SERVICE BULLETIN

M-1129

FLASHING TROUBLE CODES ON 2003 FUEL INJECTED MOTORCYCLES

Figure 1. Jumper Wire

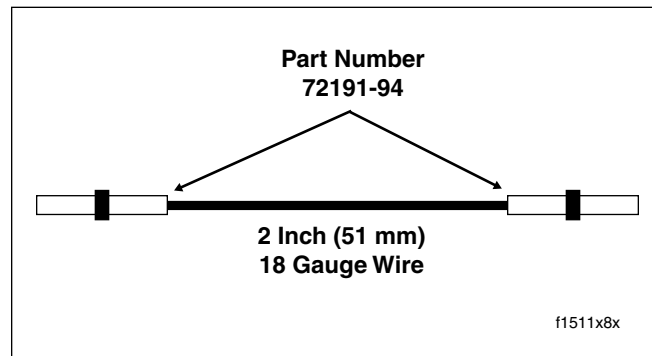
Due to changes to the ECM on 2003 fuel injected motorcycles, the procedure by which trouble codes are flashed through the check engine lamp has been affected. As a result, a slight modification to the flashing procedure must be made in order to successfully flash trouble codes.

1. Remove parts as necessary to access the data link connector.
2. Remove protective plug from the data link connector and connect one end of the jumper wire to terminal 1. See Figure 1.
3. Place the Engine Stop/Run Switch in the Run position.

4. When poised to connect the free end of the jumper wire to terminal 2, turn the ignition/light key switch to ON and quickly connect jumper wire.

5. If the jumper wire is not connected to terminal 2 within eight seconds after the ignition/light key switch is turned ON, then trouble codes will not be flashed.

If uncertain whether the connection was made before eight seconds elapsed, turn the ignition/light key switch to OFF, disconnect jumper wire from terminal 2 and return to step 4.
